ADMINISTRATIVE AMENDMENT	
File # 05AA-01844	Project # 1002330
Creation of new tracts	
<i>[Signature]</i>	
APPROVED BY	DATE

Administrative Amendment  
 Site Plan for Subdivision  
**MONTGOMERY COMPLEX**  
 3531 Montgomery Blvd. NE

Sheet 1 of 2

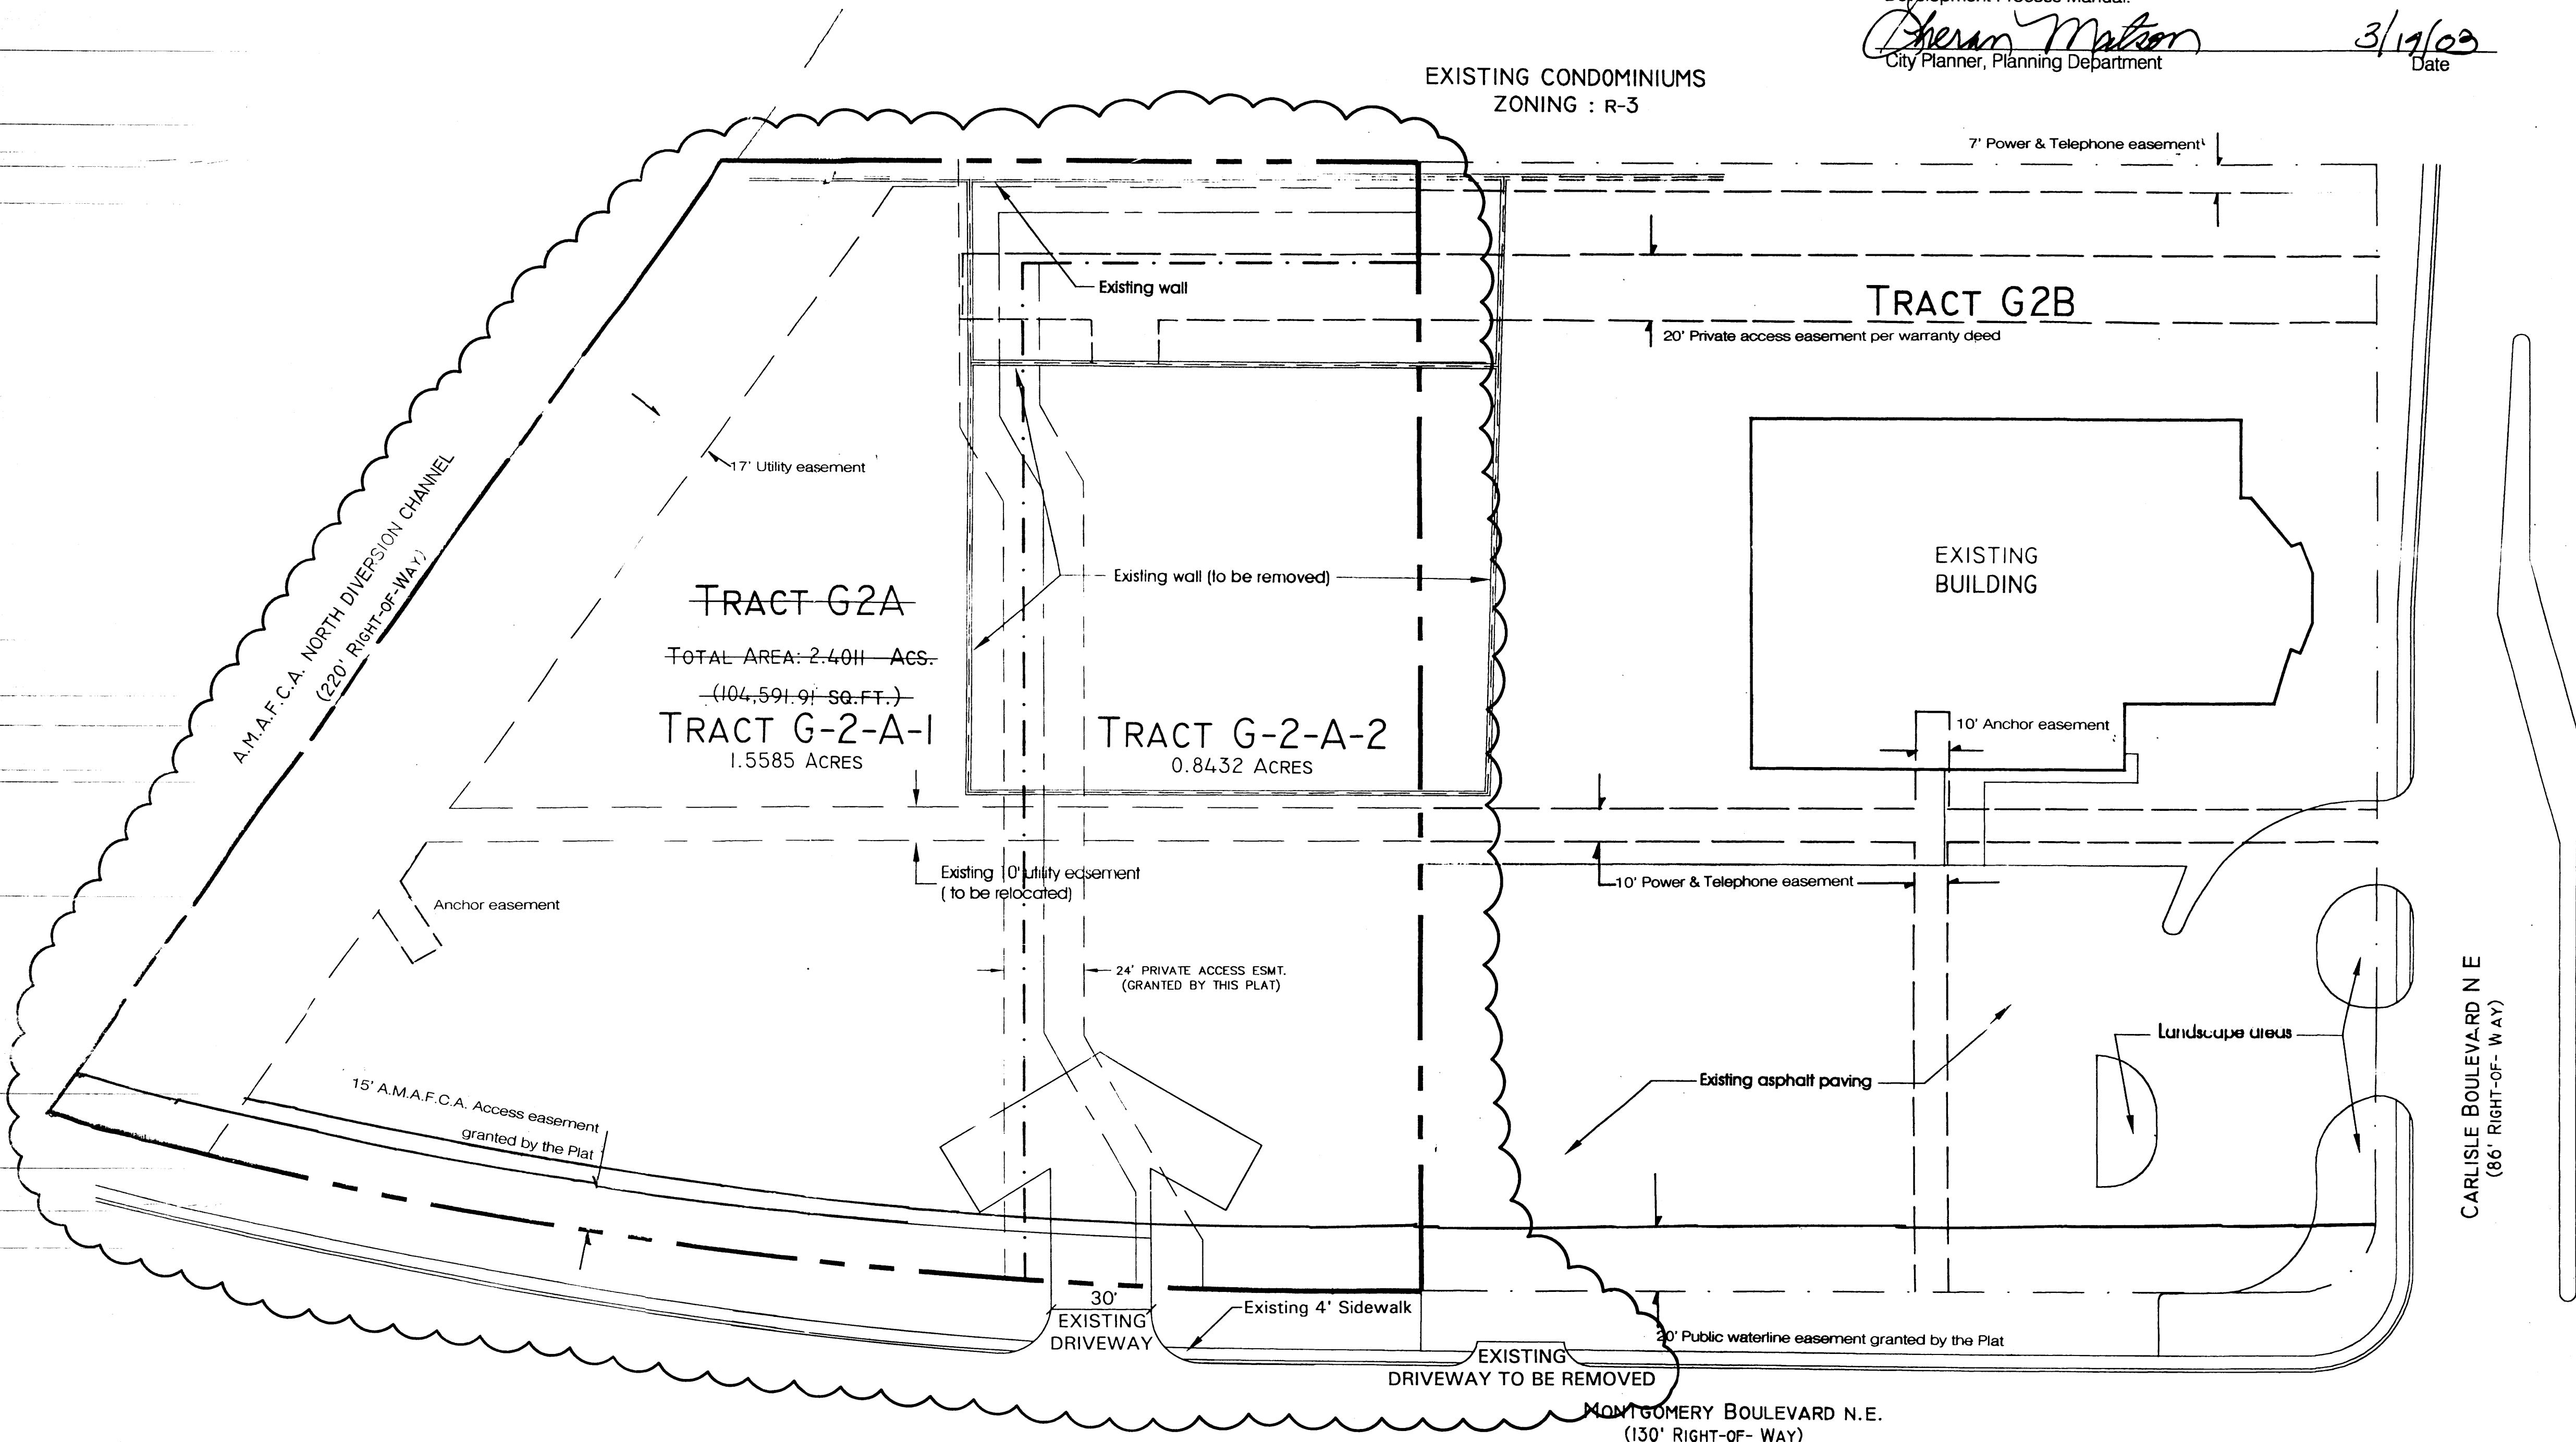
Added new Lot Line to create Tracts G-2-A1 and G-2-A-2, December 1, 2005
